UNITED STATES  
NUCLEAR REGULATORY COMMISSION  
WASHINGTON, D. C. 20555

ERRATA

Regulatory Guide 1.59, Revision 2, August 1977

"Design Basis Floods for Nuclear Power Plants"

FIGURE B.6 PROBABLE MAXIMUM FLOOD (ENVELOPING PMF ISOLINES) FOR 10,000 SQUARE MILES

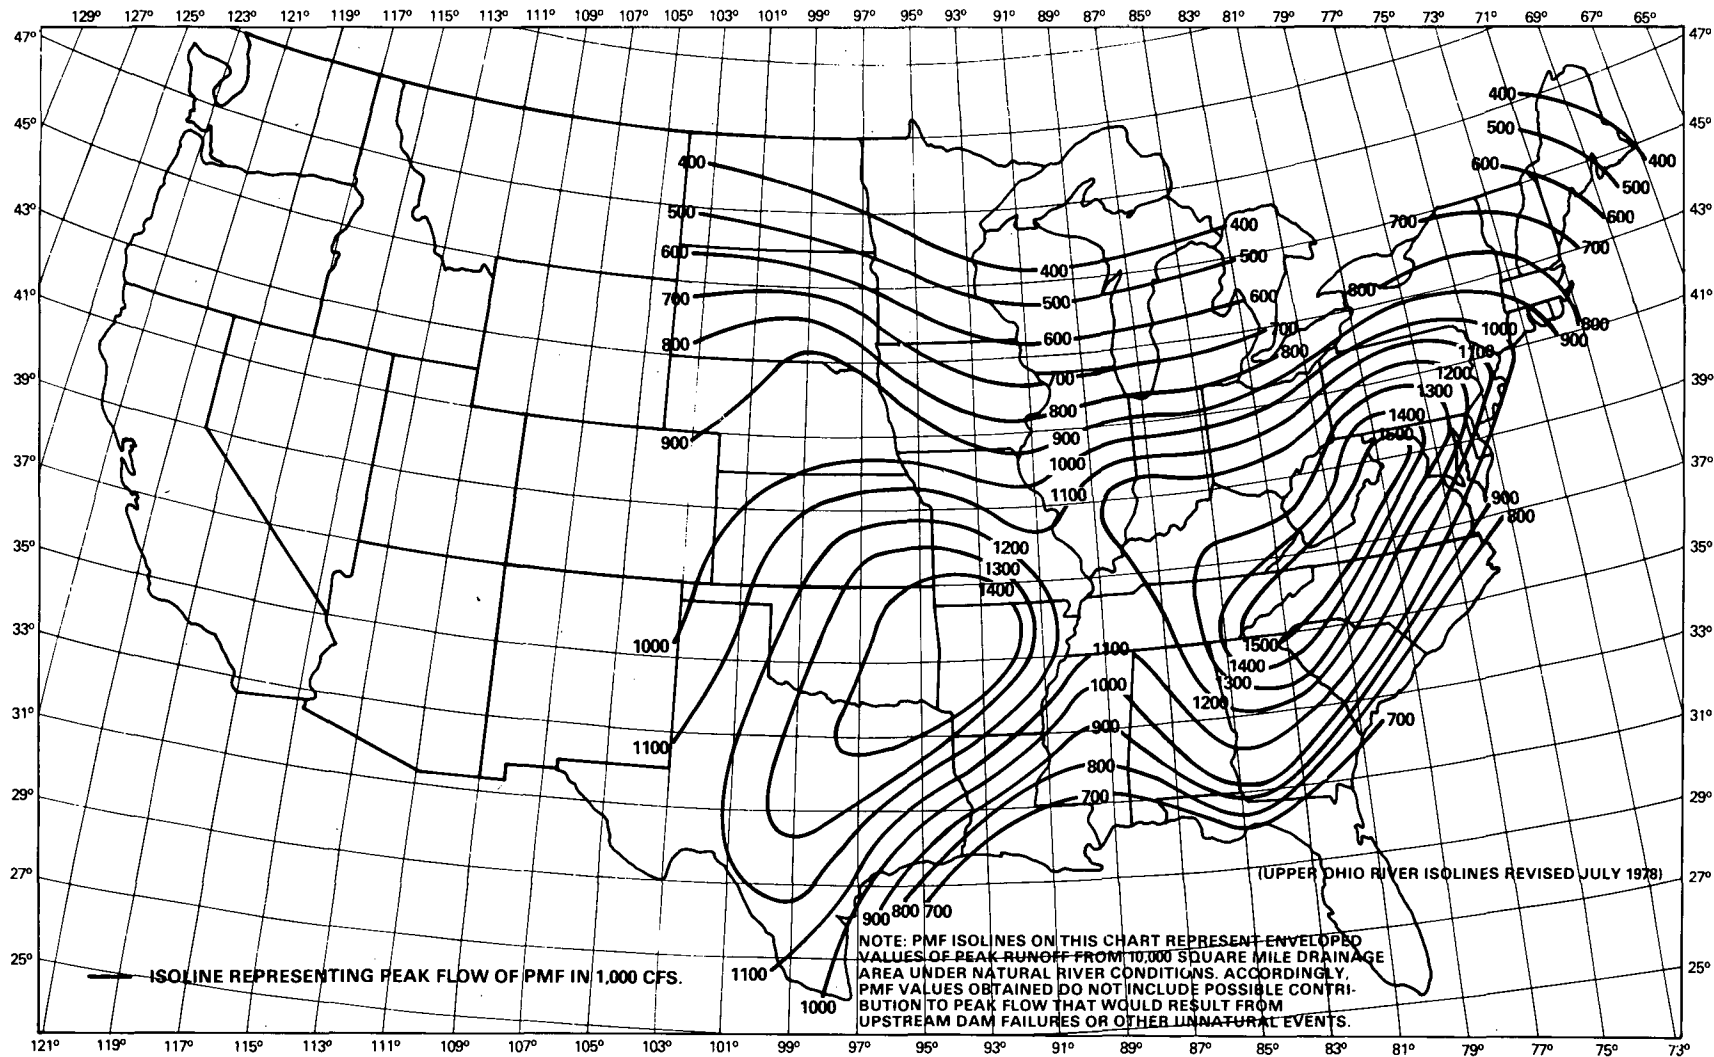
New information that affects the Probable Maximum Flood (PMF) isolines for the Upper Ohio River for drainage areas of 10,000 and 20,000 square miles has been identified. The changes to the isolines affect only a small area in the Upper Ohio River Basin and do not have any significant impact on the Design Basis Flood for existing plants.

As a result of the new information, revised Figures B.6 and B.7 transmitted herewith should be used in future PMF discharge determinations when the simplified methods presented in Appendix B to the Regulatory Guide are being used. In addition, appropriate changes have been made to the PMF data on pages 28 and 30 of Table B.1, which are also transmitted herewith.
